IDEA ONE

West Side - Big Development

East Side - Big Scoop

IDEA FOUR

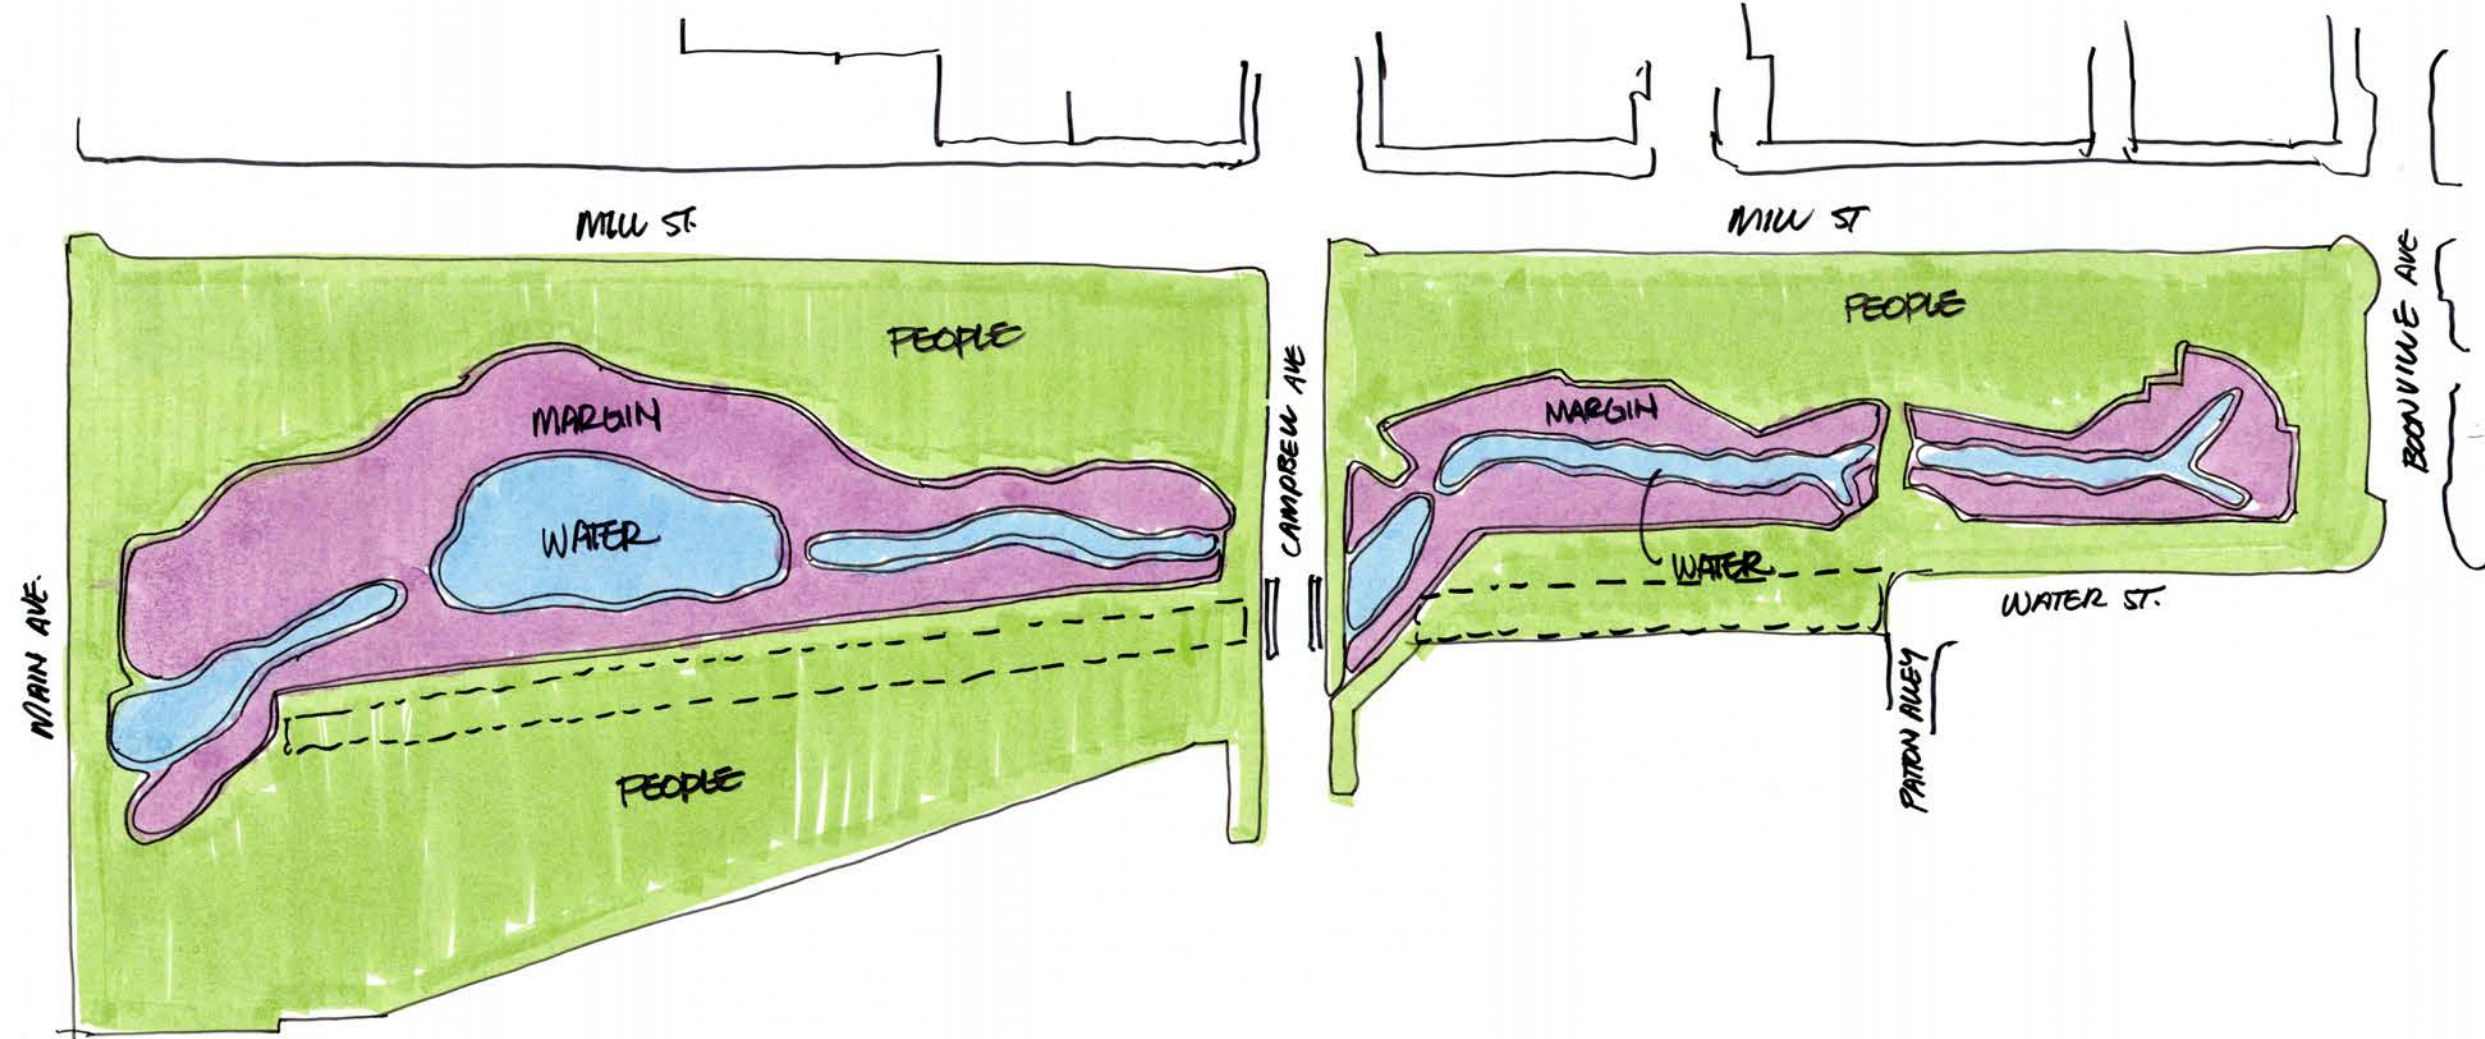
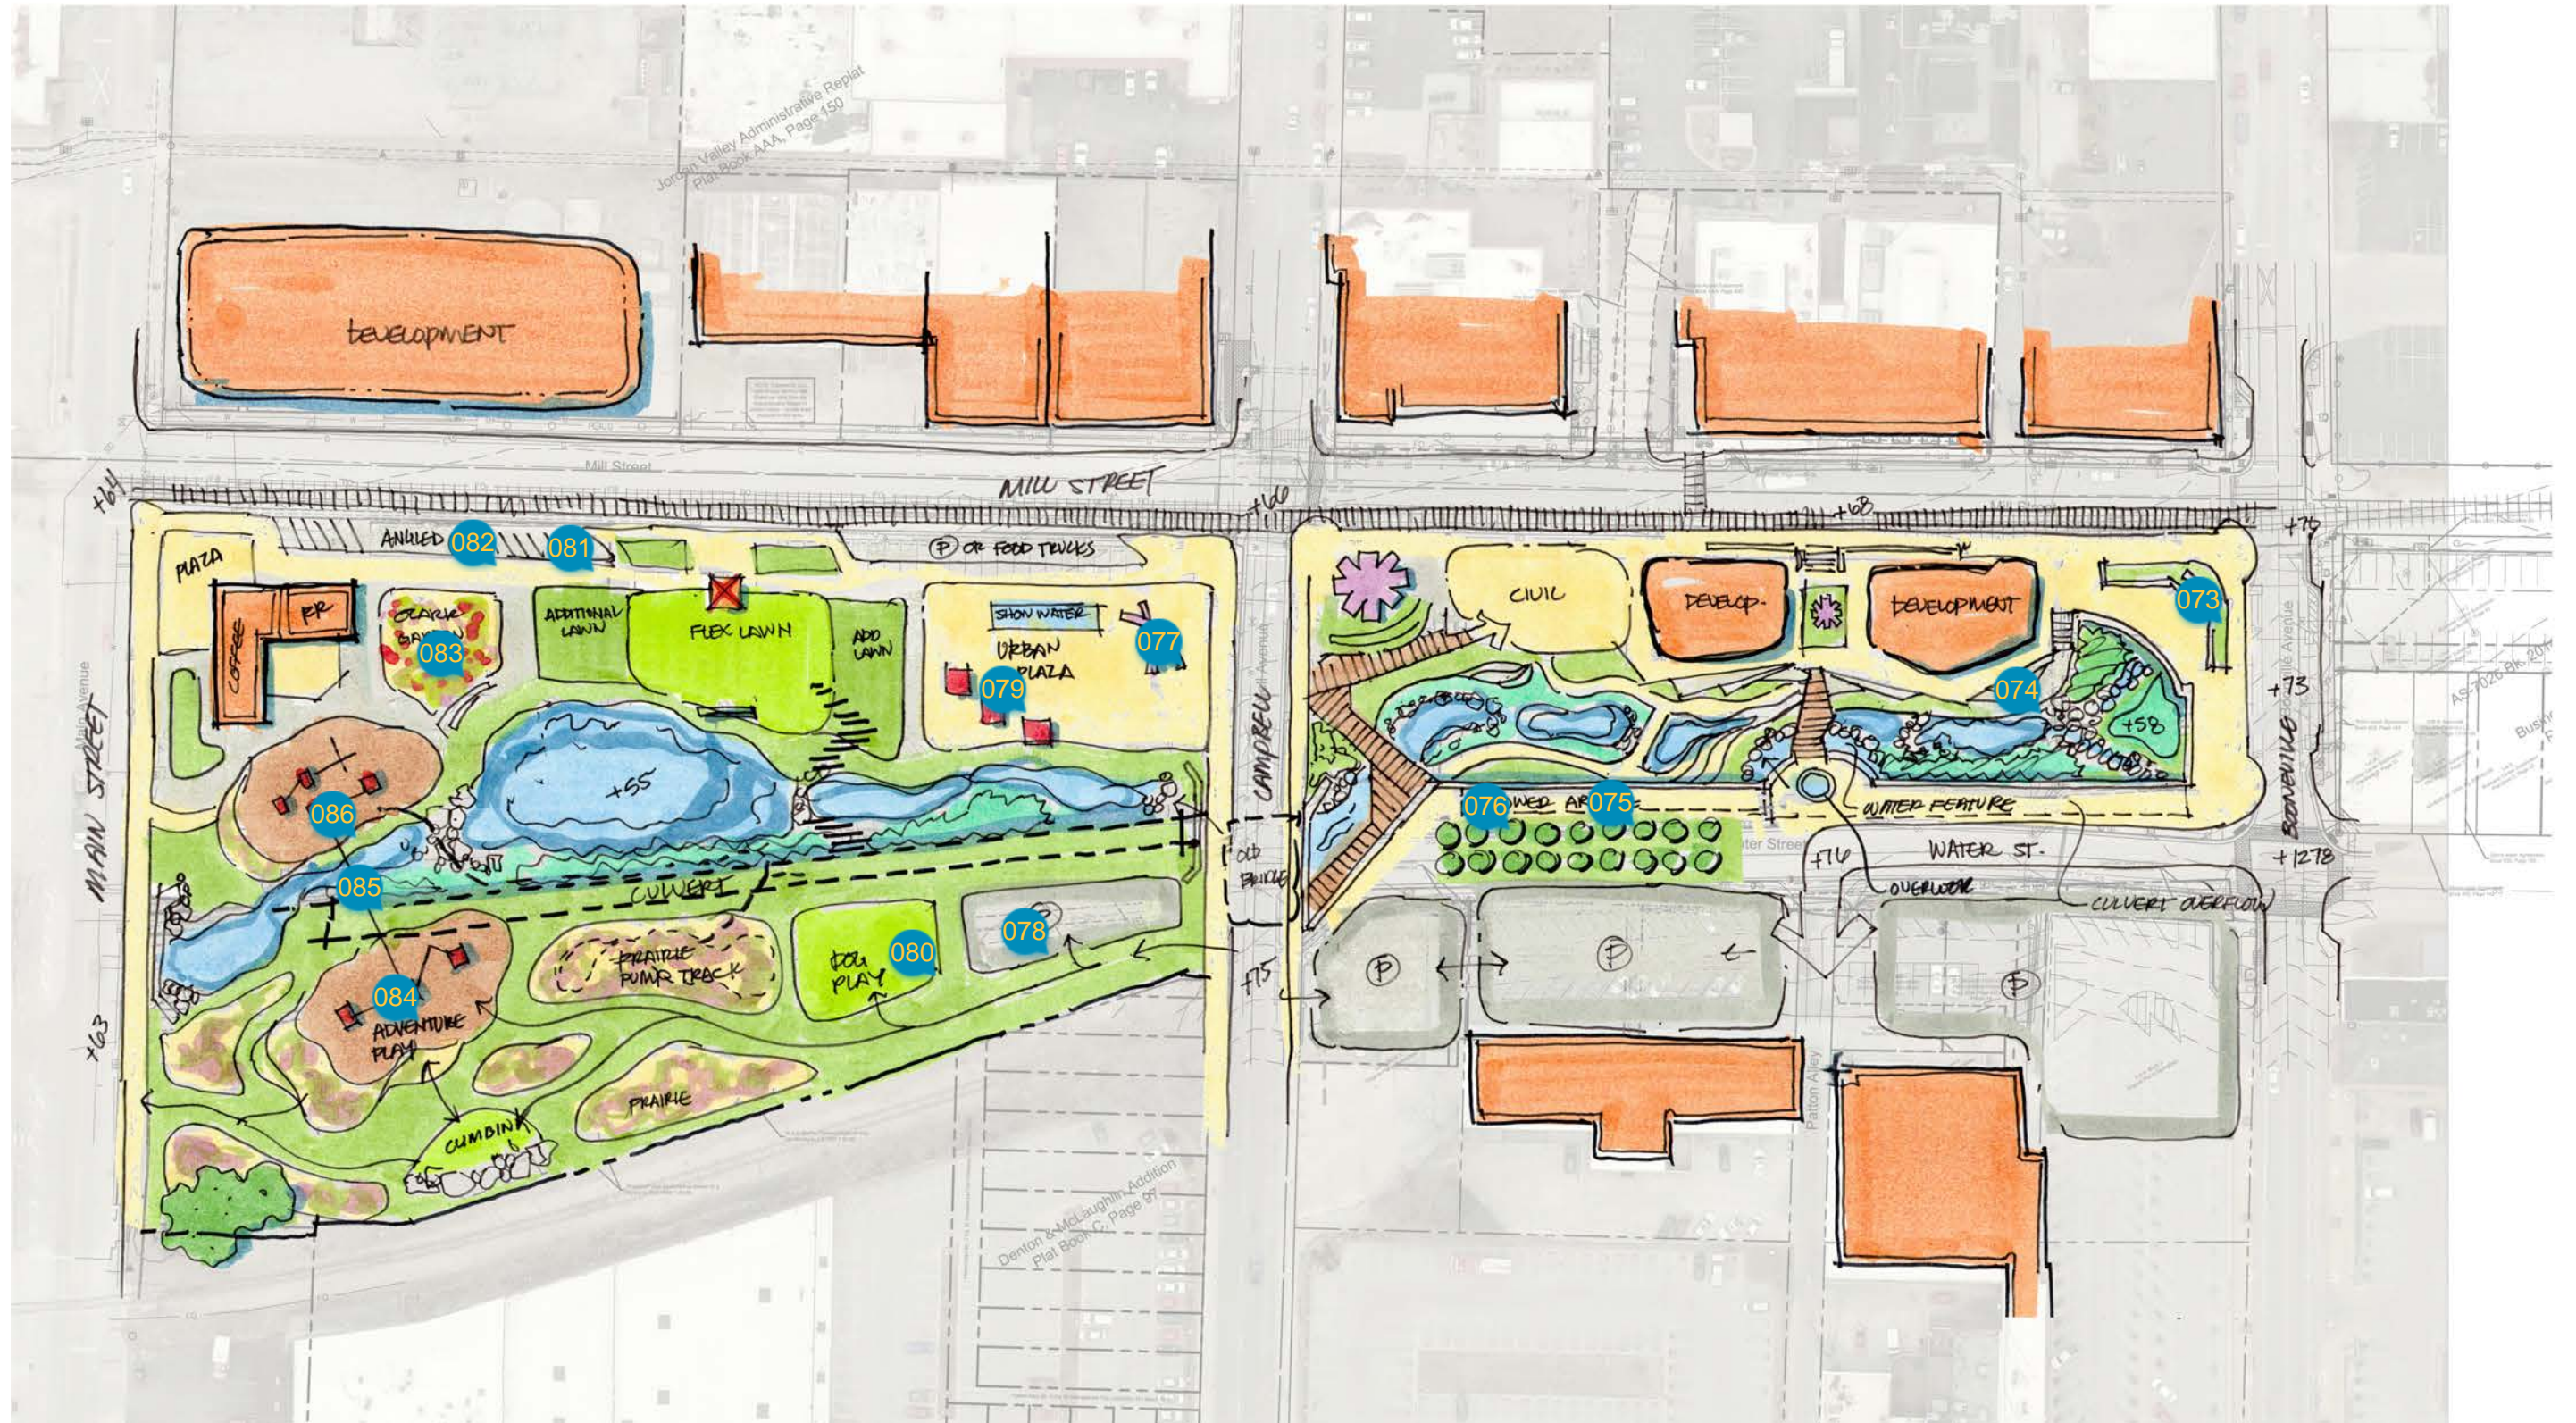
here's the grand stair! Great approach, consider how this can bottle next at the top and widen as it descends, transitioning from a pedestrian space (wide sidewalk, min 7' with center railing) to a space for sitting/gathering at the base.

Nod to FW Fountain/Phillip Johnson's Alice in Wonderland/Thru the Looking Glass? Boone has already acknowledged danger of 9' pool, but the origami folding terraces idea is strong... especially as it orients towards views of setting sun to the west or encourages sunbathing. Consider orienting more towards W/SW as grand public stair/stramp concept?

What would this area look like? Is it like an open side/covered area that used to be the box culvert? If so, the existing box culvert structure isn't too visually appealing.
